**DOCKET ITEM #9**  
**Special Use Permit #2012-0036**  
**4016 Taney Avenue – Substandard Lot**

Application	General Data	
Consideration of a request to construct a new home on a substandard lot.	Planning Commission Hearing:	May 1, 2012
	City Council Hearing:	May 12, 2012
Address: 4016 Taney Avenue	Zone:	R-8/Single-Family
Applicant: Janlan Co., LLC c/o Janet Wilcox by Johnathan Brodie, agent	Small Area Plan:	Seminary Hill/Strawberry Hill

**Staff Recommendation:** APPROVAL subject to compliance with all applicable codes and ordinances and the recommended permit conditions found in Section III of this report.

## GRADING PLAN LOT 62 SECTION 1

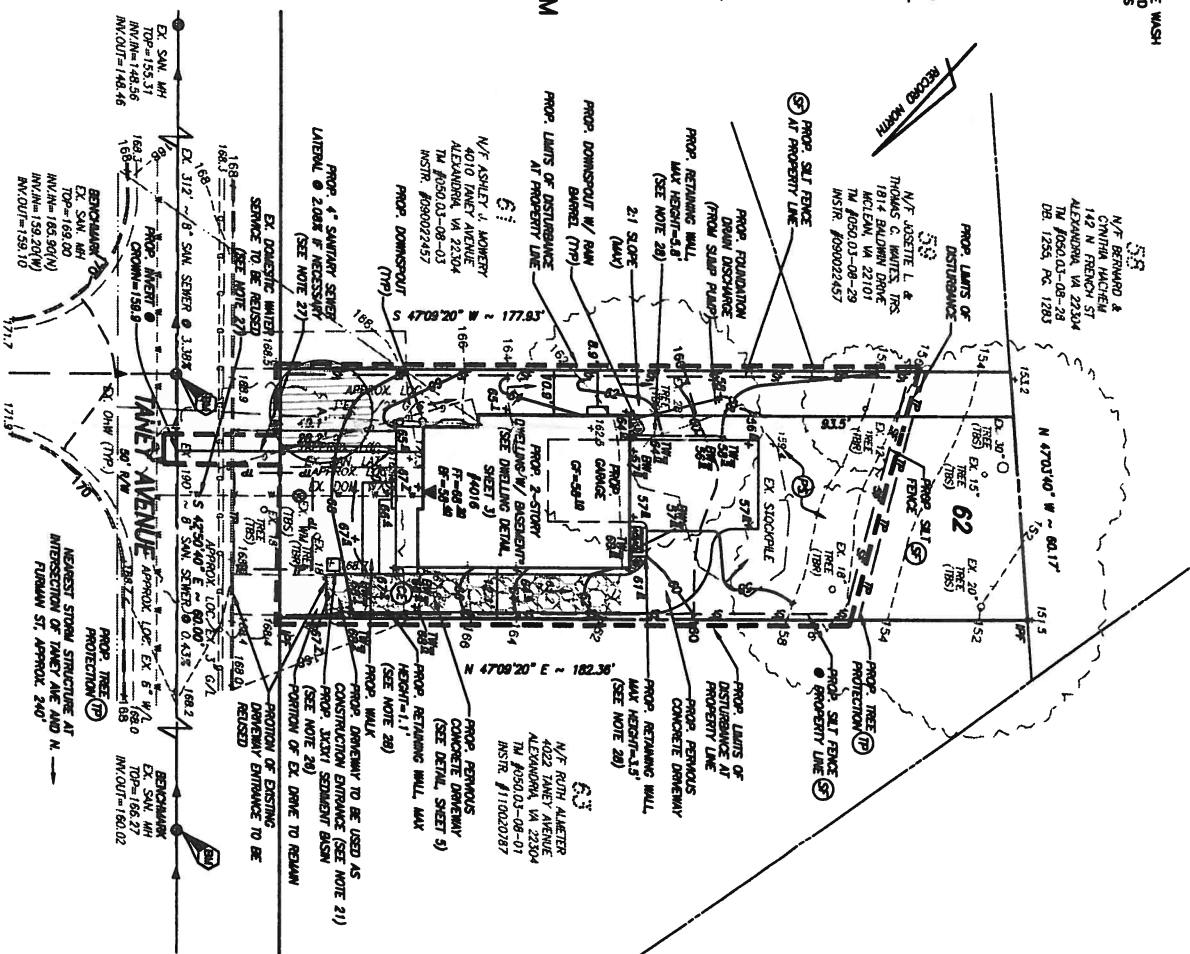
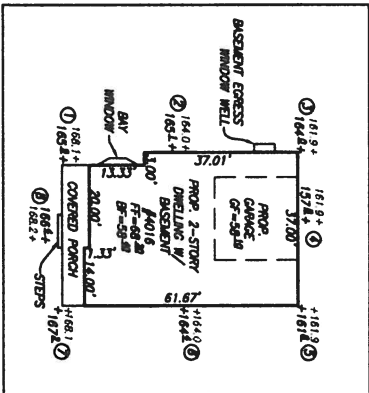
Finally, staff has included conditions designed to protect the trees on the site: the large street tree and three trees in back yard must be saved as shown on the grading plan; adequate tree protection measures must be in place; and the grade in the front yard may not substantially change.

10. The turning movements of a standard vehicle in and out of the parking garage shall be shown on the Final Site/Grading Plan. The turning movements shall meet AASHTO vehicular guidelines. (T&ES)

FRONT ELEVATION

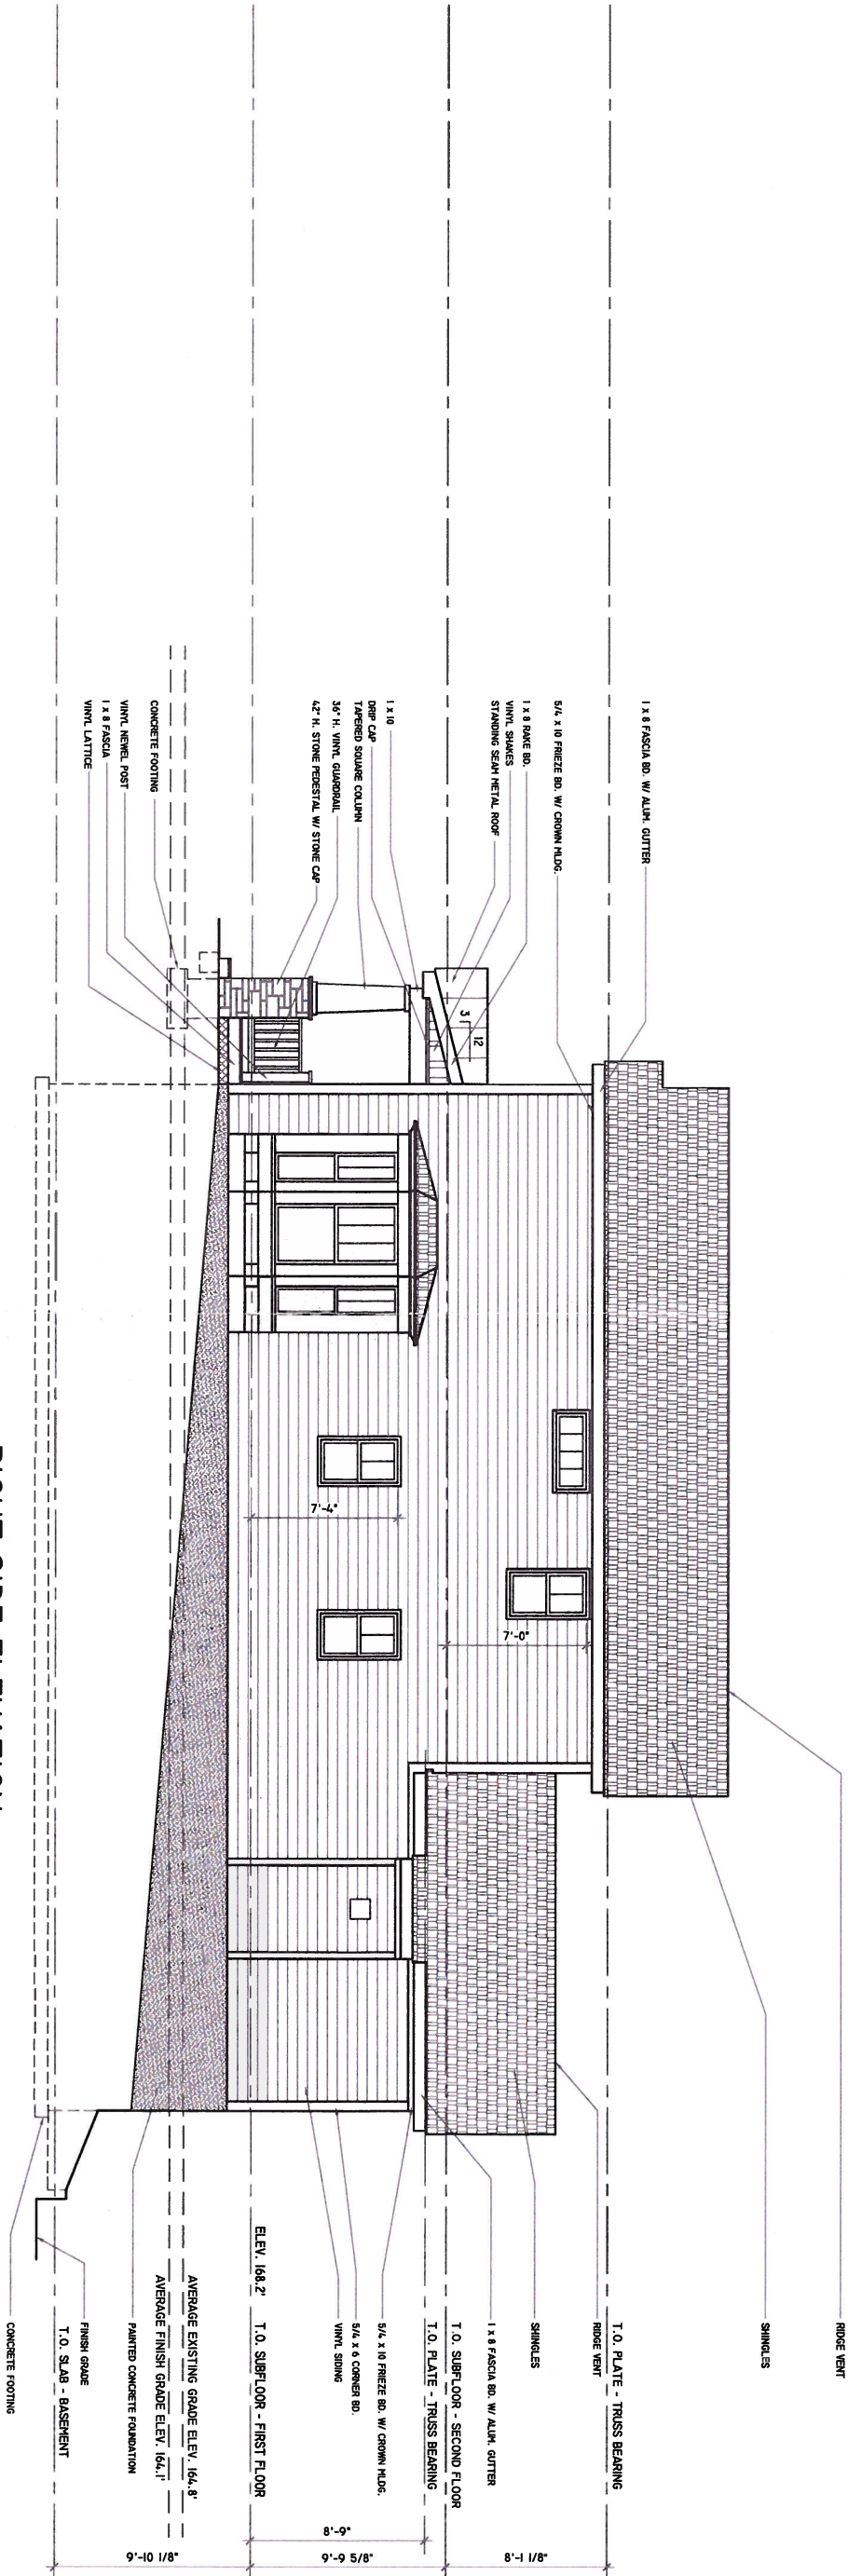
The proposed front gable projects forward of the main front building wall, but to a very slight degree. The proposed front porch is also a small one. Staff has suggested to the applicant that the projection of the gable be increased to approximately 3 feet, and that the depth of the porch be increased to no less than 5 feet. The increased depth of the porch will result in a slight shift of the entire dwelling towards the rear property line, but the dwelling will continue to comply with all setbacks, including the required established front yard setback. These minor changes will enhance the aesthetics of the dwelling and will add more usable space on the front porch. Staff has included a condition to require the applicant to work with staff regarding this design change during the grading plan and building permit review process.

- C-5 The height of the porch above grade is not clearly shown based on all grade points. If at any point the height above grade is > 30" porches must have guardrails on open sides. Guardrails and intermediate rails must comply with USBC.

1. The design of the dwelling shall be substantially consistent with illustrations submitted on April 11, 2012. However, as stated in the staff report, the applicant must work with staff regarding the depth of the front porch and the front gable projection to the satisfaction of the Director of Planning and Zoning. (P&Z)
2. The first 30' from the curb line of the existing concrete driveway shall remain and all new driveway areas shall be constructed of a permeable paving system to the satisfaction of the Director of Planning and Zoning. (P&Z)
3. The 18" maple tree in the public right-of-way shall be saved. A tree protection area shall be established that is not less than 20' from the trunk in two directions (south east and
